**PLANNED UNIT DEVELOPMENT  
& SUBDIVISION STAFF REPORT****Date: August 3, 2006****DEVELOPMENT NAME**

Chrysler-Jeep Subdivision

Planned Unit Development Approval to allow multiple  
buildings on a single building site (for an existing auto dealership).

# SITE PLAN

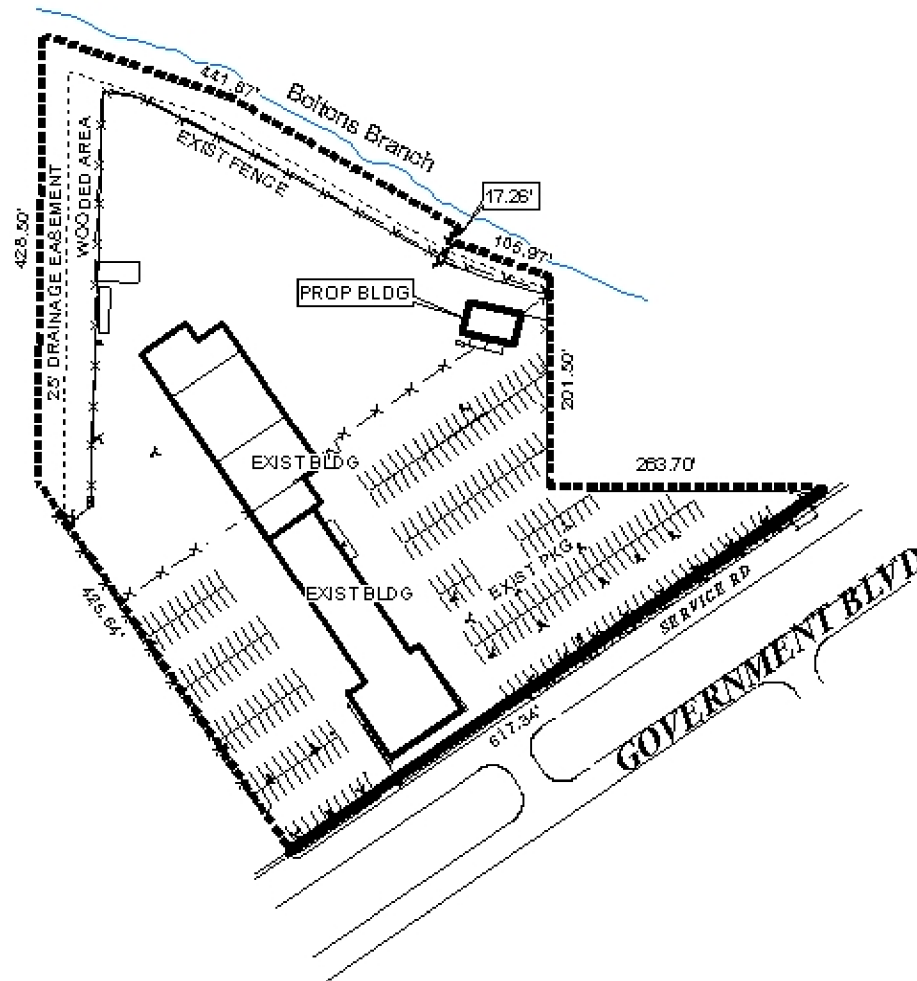
Year 2002 aerial photographs, as well as the site plan provided by the applicant, show that the existing single-family homes are buffered from the site by an existing wooded area that is on the site in question. It is recommended that the wooded area be maintained, and where necessary infilled with additional plantings, in order to fulfill the commercial / residential buffering requirements.

The 25-foot minimum building setback line, required in Section V.D.9., is not shown for the subdivision, but would be required on the Final Plat, if approved.
